Change Notice

PCN No: 129

Notice Type: Product Revision Change

Product Type: SL164

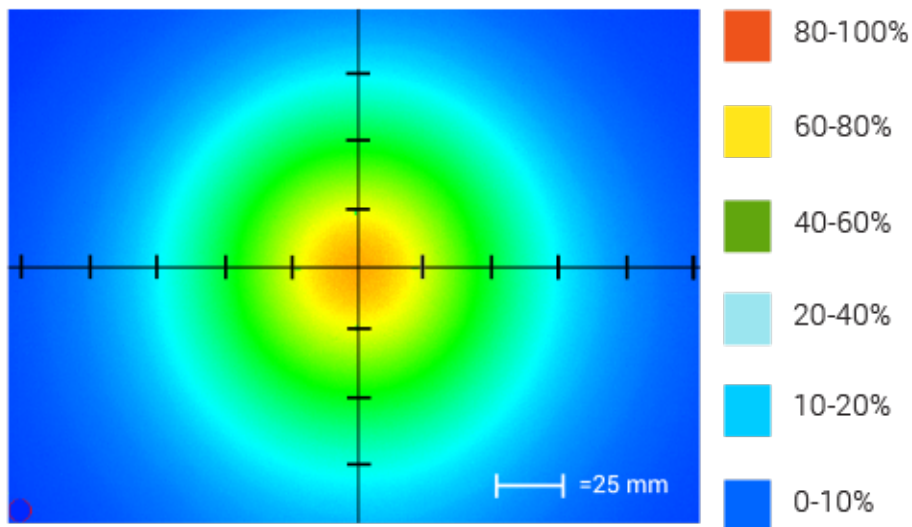
In an effort to improve our products, Advanced illumination (Ai) will update the LEDs used in the SL164 design. This change will result in a brighter, more uniform light at the same price*. Customers may still buy the current revision of this model until July 15th of 2016. After that time, orders for these products will be converted to their respective SL164 Revision A models.

This LED change will result in additional wavelengths being available: 365nm, 375nm, 385nm, 395nm, 405nm, 455nm, 470nm, 505nm, 530nm, 590nm, 625nm, 660nm, 730nm, 850nm and 940nm. Additionally the white LED color temperature will be changing from 6100K to 5500K.
